Access Compliance Report

Public Rights-of-Way

Intersection ID: 49140	Main Street: POPE_FARM_RD	Cross Street: CEMKEY_WAY_CT	Location: SE
ADA ID: DA64F65221A7	Ramp Type: Perp	Initial Pass/Fail: Fail	Overall Compliance: No
Severity Score: 8.75			
Codes/Mitigation Info/Possible Solution		Field Measurements/Component Compliance

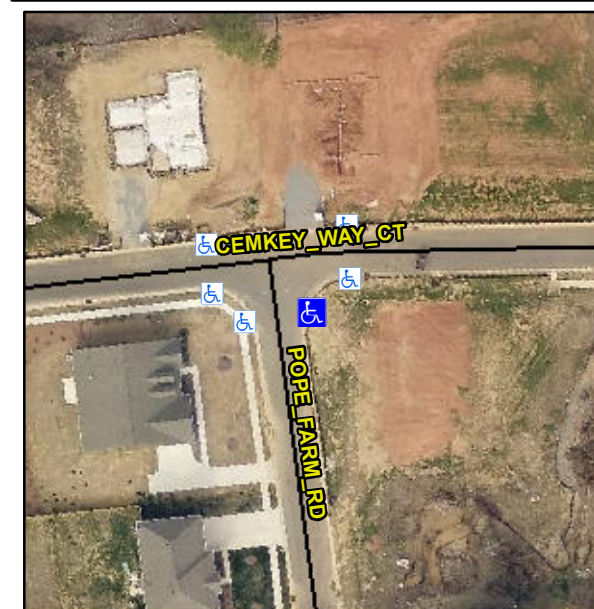
Not Found, R304.5.1

Compliance	Description	Data	Compliance	Description	Data
N/A	Ramp Length (in)	50.0	Yes	Ramp Slope (%)	6.7
No	Ramp Width (in)	46.0	Yes	Ramp XSlope (%)	0.9
N/A	Flare Type LT	N/A	N/A	Flare Type RT	N/A
N/A	Flare Slope LT (%)	N/A	N/A	Flare Slope RT (%)	N/A
N/A	Flare Traversable LT?	N/A	N/A	Flare Traversable RT?	N/A
N/A	Landing Length (in)	N/A	N/A	DWS Provided?	N/A
N/A	Landing Width (in)	N/A	N/A	DWS Contrast?	N/A
N/A	Landing Slope (%)	N/A	N/A	DWS Length (in)	N/A
N/A	Landing X Slope (%)	N/A	N/A	DWS Full Width?	N/A
N/A	Landing Curb? (Y/N)	N/A	N/A	DWS Offset (in)	N/A
N/A	Shared Landing?	N/A			
N/A	Gutter Ponding?	N/A	N/A	Gutter Slope (%)	N/A
N/A	Gutter Lip Ht (in)	N/A	N/A	Gutter X Slope (%)	N/A
N/A	Painted X Walk1?	No	N/A	Painted X Walk2?	N/A
	X Walk 1 Direction	To W		X Walk 2 Direction	N/A
N/A	X Walk 1 Width (in)	N/A	N/A	X Walk 2 Width (in)	N/A
	X Walk 1 Slope (%)	3.1		X Walk 2 Slope (%)	N/A
	X Walk 1 X Slope (%)	2.2		X Walk 2 X Slope (%)	N/A

Remove & Replace Entire Ramp.
